Technical Service Bulletin

Product Description: AMSOIL Premium API CJ-4 Diesel Oil (DEO, DME)

Subject: Fuel Dilution Issues in 2007 – Present Light-Duty Turbo-Diesel Pickups

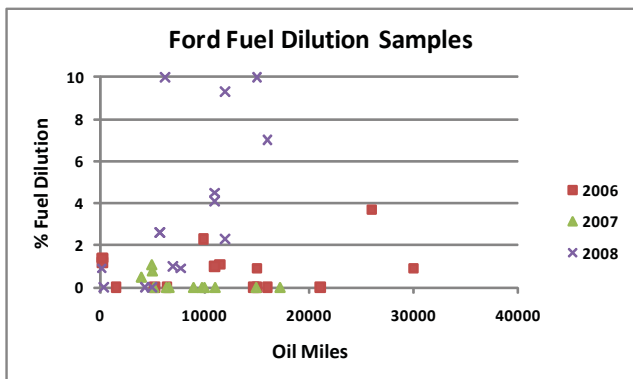
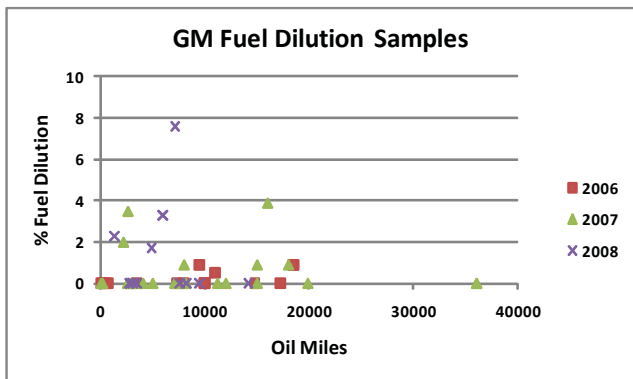
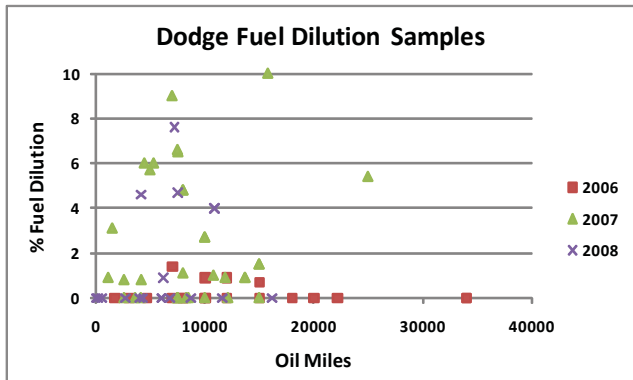
As illustrated in the charts, model-year 2007 and newer light-duty diesels are experiencing higher fuel dilution than previous model years. Although these vehicles are experiencing higher fuel dilution, regeneration cycles vary based on service (engines operating in severe service conditions do not actively regenerate as often as engines operating in

In these applications, AMSOIL recommends changing AMSOIL Premium API CJ-4 Synthetic Diesel Oil (DEO, DME) at the manufacturer-recommended drain interval. Drain intervals may be extended further with oil analysis. The recommendation for this oil in gasoline applications remains 2X vehicle manufacturer recommendation.³
